Access Compliance Report

Public Rights-of-Way

Intersection ID: 45502	Main Street: CAPTAIN_ARDREY_RD	Cross Street: TRIPLE_OAK_RD	Location: S
ADA ID: D72F24374025	Ramp Type: PerpDiag	Initial Pass/Fail: Fail	Overall Compliance: No
Codes/Mitigation Info/Possible Solution		Field Measurements/Component Compliance

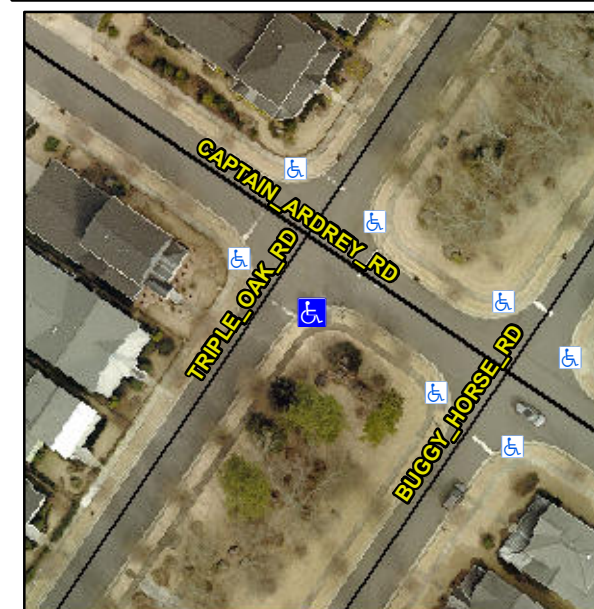
Not Found, R304.5.1, R304.2.2, R304.5.3

Compliance	Description	Data	Compliance	Description	Data
N/A	Ramp Length (in)	72.0	No	Ramp Slope (%)	12.8
No	Ramp Width (in)	35.0	No	Ramp XSlope (%)	2.3
N/A	Flare Type LT	N/A	N/A	Flare Type RT	N/A
N/A	Flare Slope LT (%)	N/A	N/A	Flare Slope RT (%)	N/A
N/A	Flare Traversable LT?	N/A	N/A	Flare Traversable RT?	N/A
N/A	Landing Length (in)	N/A	N/A	DWS Provided?	N/A
N/A	Landing Width (in)	N/A	N/A	DWS Contrast?	N/A
N/A	Landing Slope (%)	N/A	N/A	DWS Length (in)	N/A
N/A	Landing X Slope (%)	N/A	N/A	DWS Full Width?	N/A
N/A	Landing Curb? (Y/N)	N/A	N/A	DWS Offset (in)	N/A
N/A	Shared Landing?	N/A			
N/A	Gutter Ponding?	N/A	N/A	Gutter Slope (%)	N/A
N/A	Gutter Lip Ht (in)	N/A	N/A	Gutter X Slope (%)	N/A
N/A	Painted X Walk1?	No	N/A	Painted X Walk2?	No
	X Walk 1 Direction	To NE		X Walk 2 Direction	To NW
N/A	X Walk 1 Width (in)	N/A	N/A	X Walk 2 Width (in)	N/A
	X Walk 1 Slope (%)	1.3		X Walk 2 Slope (%)	3.7
	X Walk 1 X Slope (%)	3.3		X Walk 2 X Slope (%)	0.3

Remove & Replace Curb Ramp With Two New Directional Ramps or Equivalent.
